Case Number: R18011

**CASE COMMENTS:**

**Prior to Final DRC Sign Off, the applicant shall address these comments:**

Existing Stormwater Asset Map possibly affected by the Proposed Development

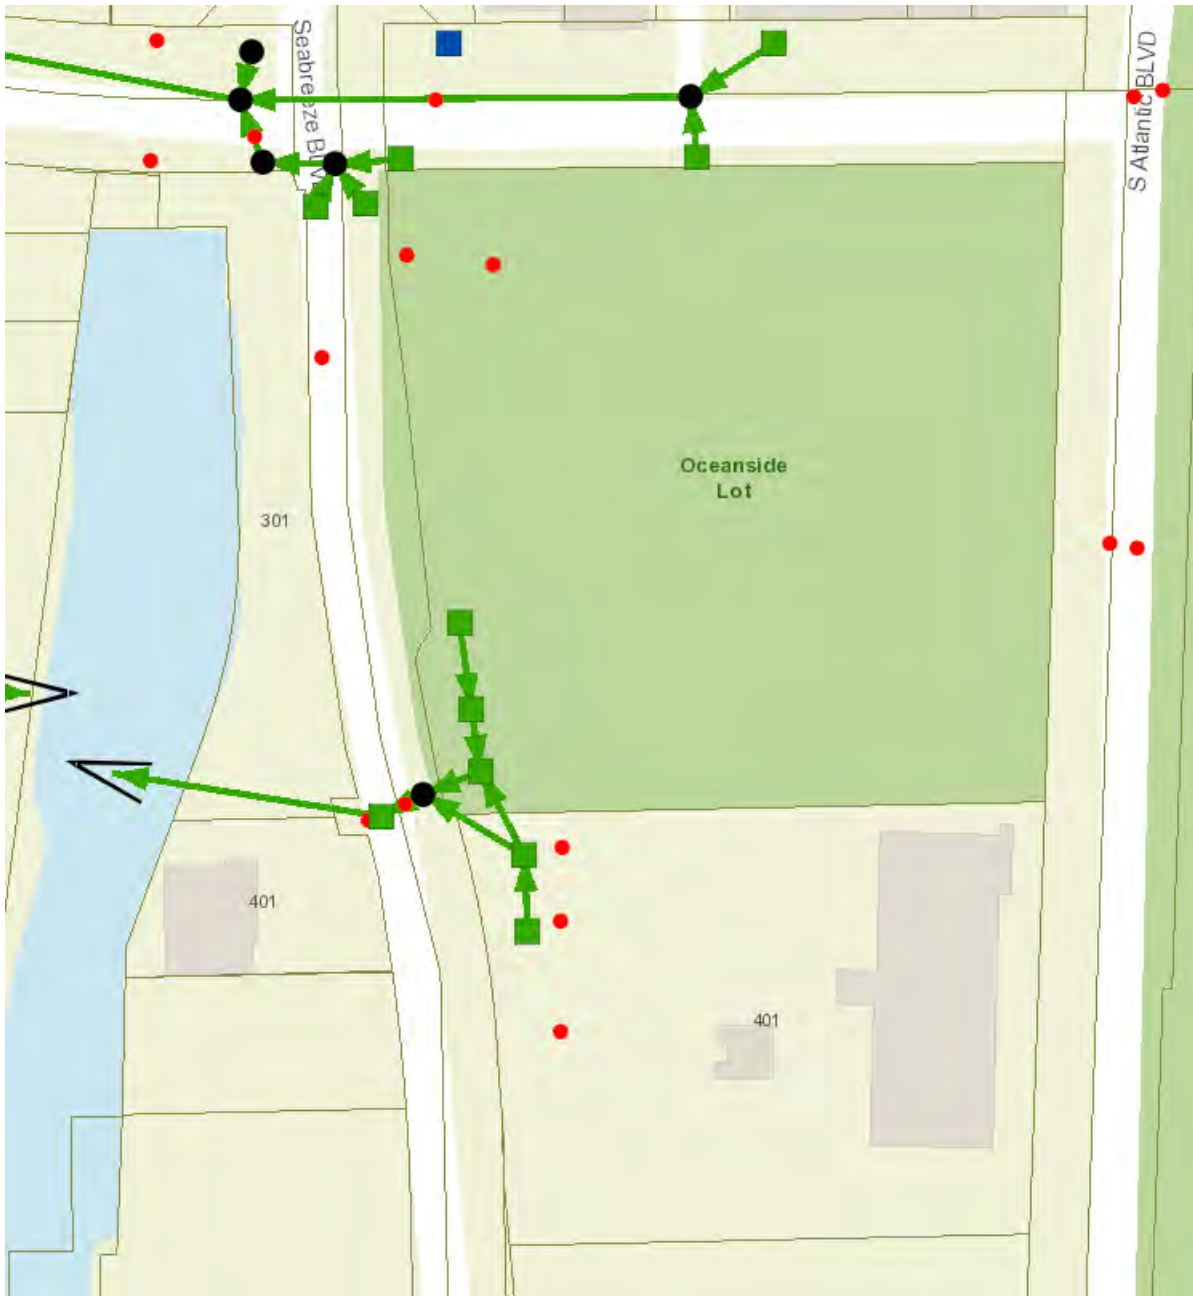
The City owns and maintains stormwater infrastructure adjacent to the proposed development as shown with green line work in the map provided at the end of this report. The following comments pertain to possible impacts of the proposed development and/or construction activities to the existing condition of the City's stormwater assets. The applicant shall provide an itemized response letter addressing the following comments:

1. Please prepare and submit a separate utility demolition plan for review of impact to existing City's stormwater systems. City's GIS shows existing stormwater assets connected from onsite to offsite, which may need further evaluation for disconnection as appropriate.

2. Please provide (or revise if already submitted) an erosion, sedimentation, and stormwater pollution prevention plan (**SWPPP**) showing the adjacent City's existing stormwater system as shown in the survey and to the limits shown with green line work in the storm map provided at the end of this report. A copy of the approved SWPP shall be at the construction site from the date of demolition initiation to the date of final construction activities.

- a) Contractor shall provide CCTV videotapes to City STW OPS of the existing stormwater system to the limits shown with green line work in the storm map provided at the end of this report in order to document the PRE and POST construction conditions of the City's storm system.
